REACTIVITY CONTROL SYSTEMS

SHUTDOWN MARGIN - MODES 3, 4 AND 5

LIMITING CONDITION FOR OPERATION

FIGURE 3.1-3

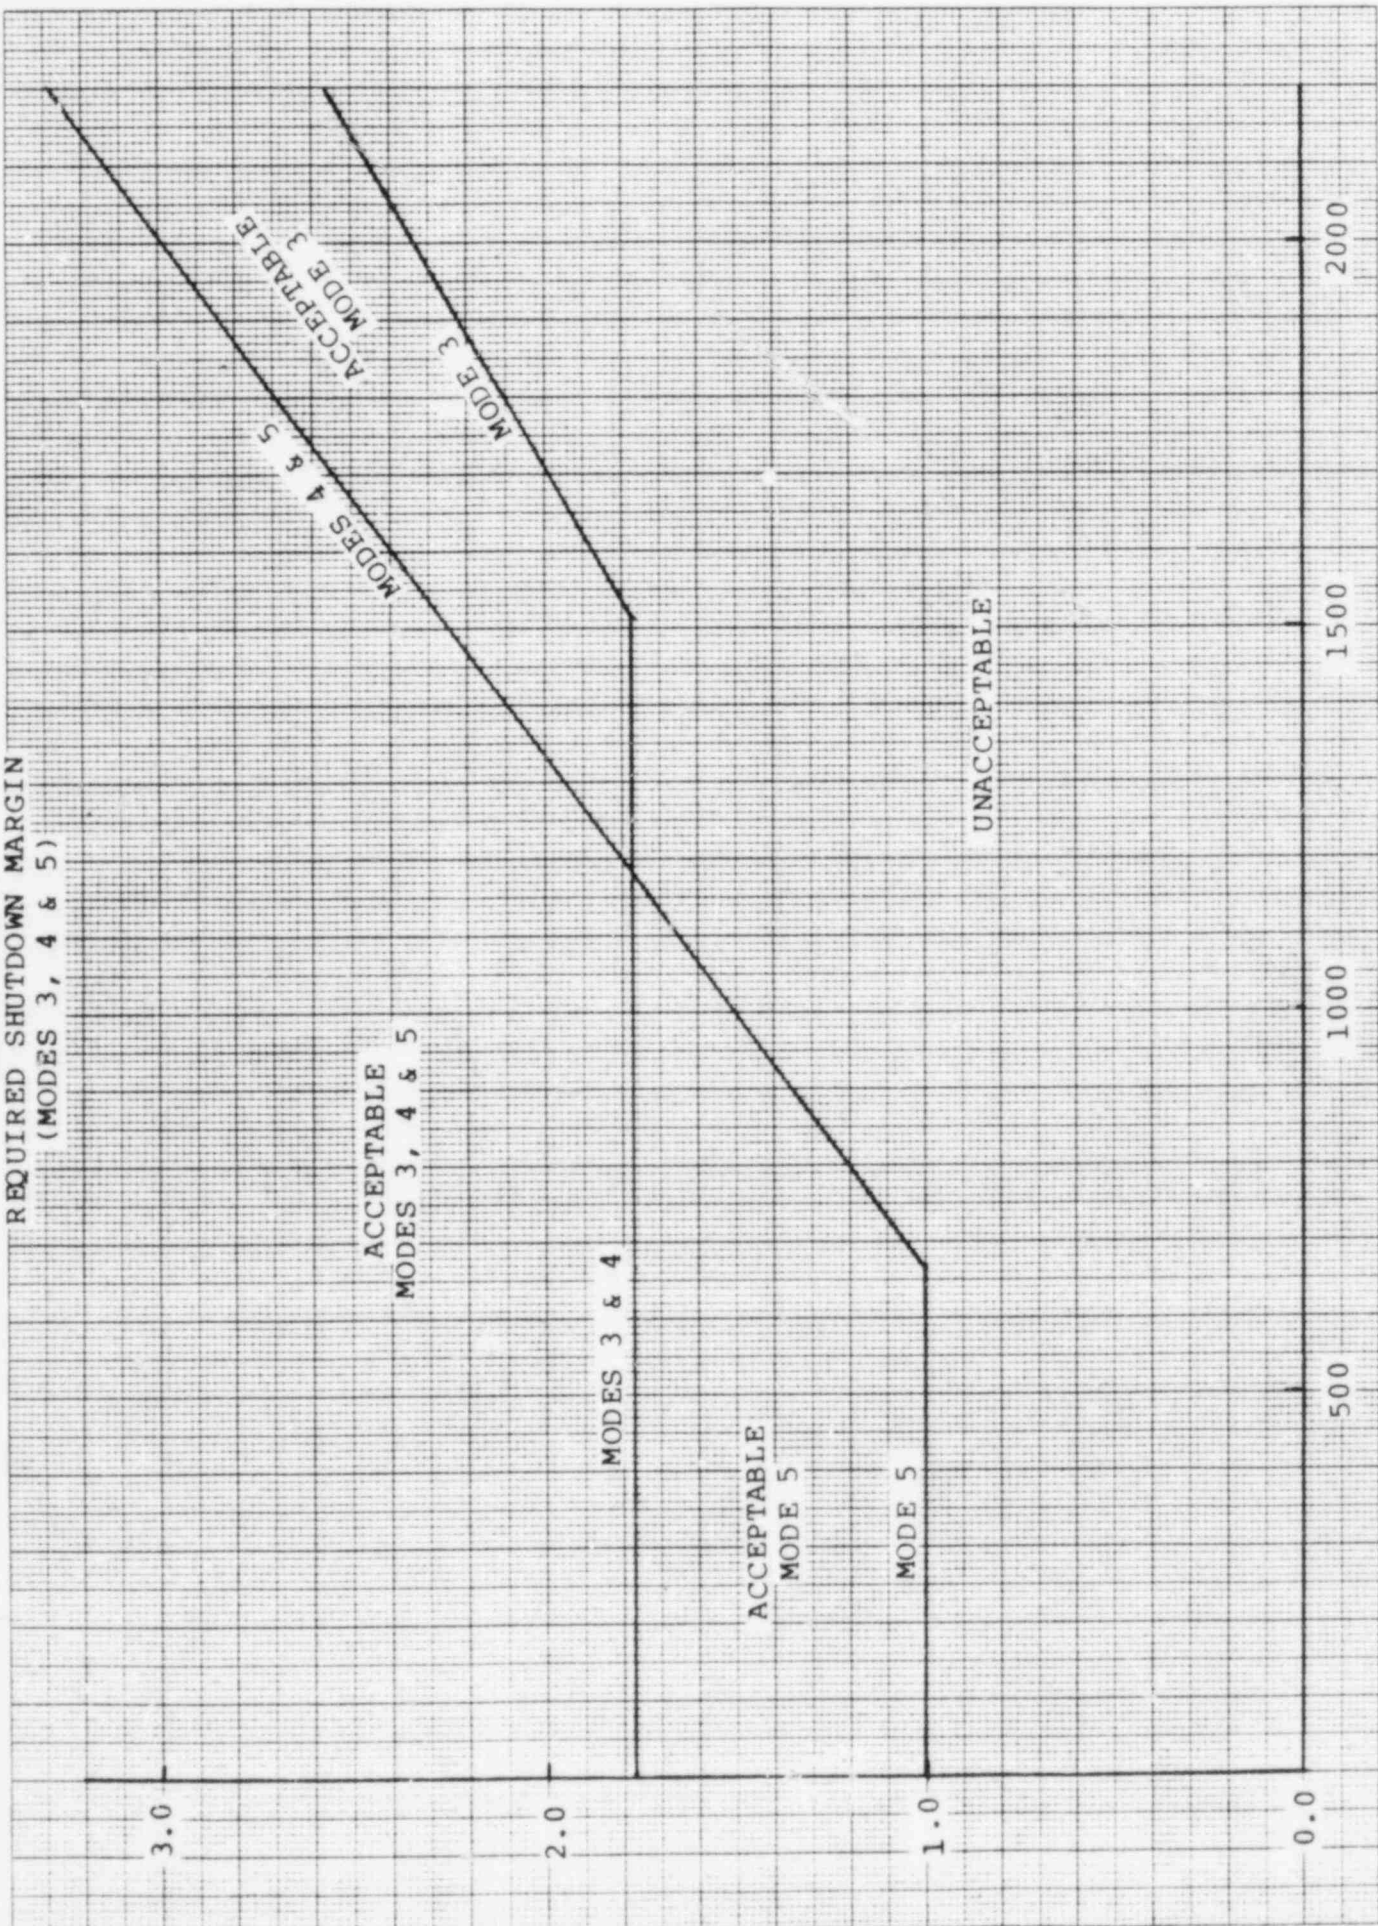
3.1.1.2 The SHUTDOWN MARGIN shall be greater than or equal to ~~2.0% delta k/k~~.

↑ THE LIMITS SHOWN IN  
FIGURE 3.1-3.

With the SHUTDOWN MARGIN less than <sup>THE REQUIRED VALUE</sup> ~~2.0% delta k/k~~, immediately initiate and continue boration at greater than or equal to 30 gpm of a solution containing greater than or equal to 7000 ppm boron or equivalent until the required SHUTDOWN MARGIN is restored.

4.1.1.2 The SHUTDOWN MARGIN shall be determined to be greater than or equal to ~~2.0% delta k/k~~: <sup>THE REQUIRED VALUE</sup>

↑  
IS VARIED AS A FUNCTION OF AVERAGE  
RCS BORON CONCENTRATION IN ORDER TO
